Aire Valley Tree Consultancy Ltd.

Written Objection to TREE PRESERVATION ORDER - TPO 5/2022 - Hawkesworth House, Nesfield, Ilkley, LS29 0BS

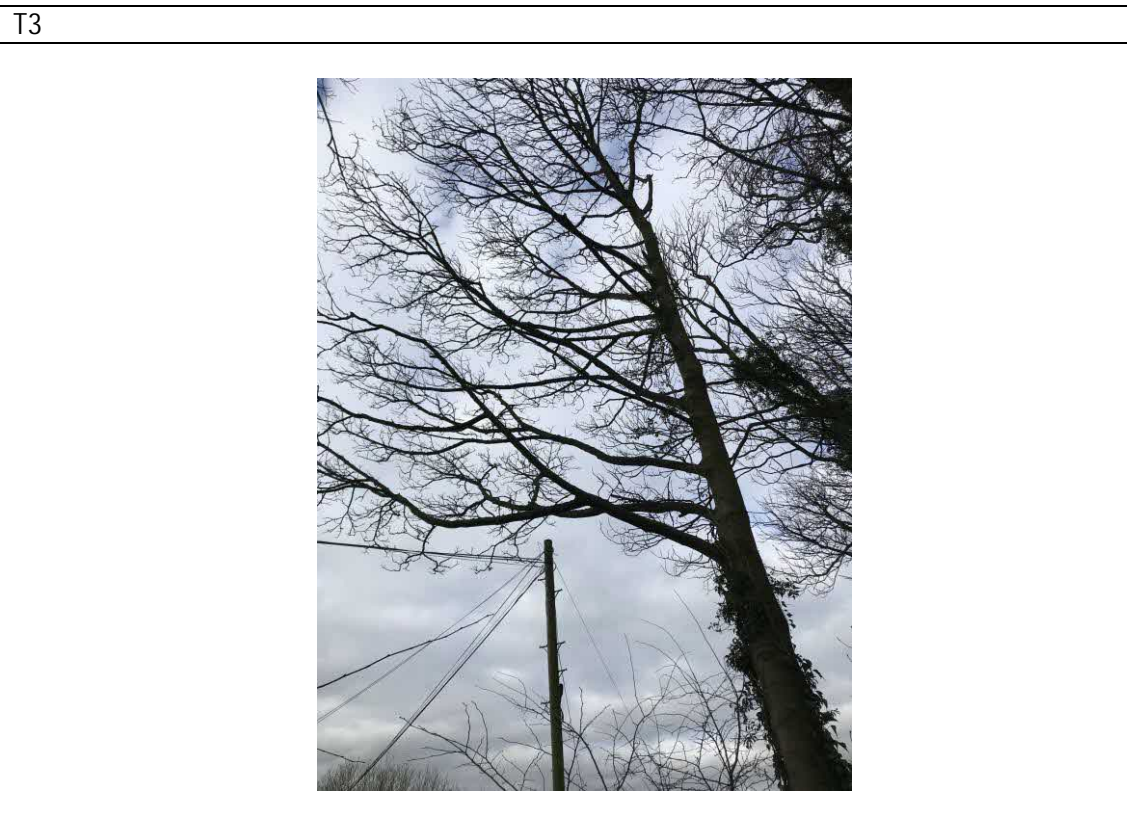
Both trees are Sycamore. The S211 notification to fell appears reasonable management of the group as a whole. These trees have genetic potential to be significant in size (likely 15-18m at this location, looking at adjacent mature Sycamore field trees) if retained. They are weight bias away from the group growing towards the applicants dwelling, car parking and amenity areas and will soon outgrow their location, trees unlikely to form structurally sound trees in the future. Good formed, upright Sycamores with higher canopies are proposed for retention behind T1 and T2 so the edge of the group and amenity provided will not be altered in any great way. The stems of both trees are approximately 60cm from the applicant's boundary wall. Table A1 of BS5837 indicates trees which will mature to have stems between 300mm and 600mm (e.g. Sycamore) should be a minimum of 1m from masonry boundary walls to prevent damage. While this wall appears partially masonry, partial dry stone T1 and T2 have the potential to damage this wall (which acts as a current boundary).

As such we object to the TPO as this prevents reasonable management of trees TPO trees T1 and T2.

T1 and T2 labelled yellow showing their weight bias form. Trees unlikely to form structurally sound trees in the future

T1 and T2 labelled yellow, better formed trees to rear labelled in blue that have longevity in form and distance from walls

T1 and T2 labelled yellow showing their proximity to wall

T1 and T2 labelled yellow showing their proximity to wall
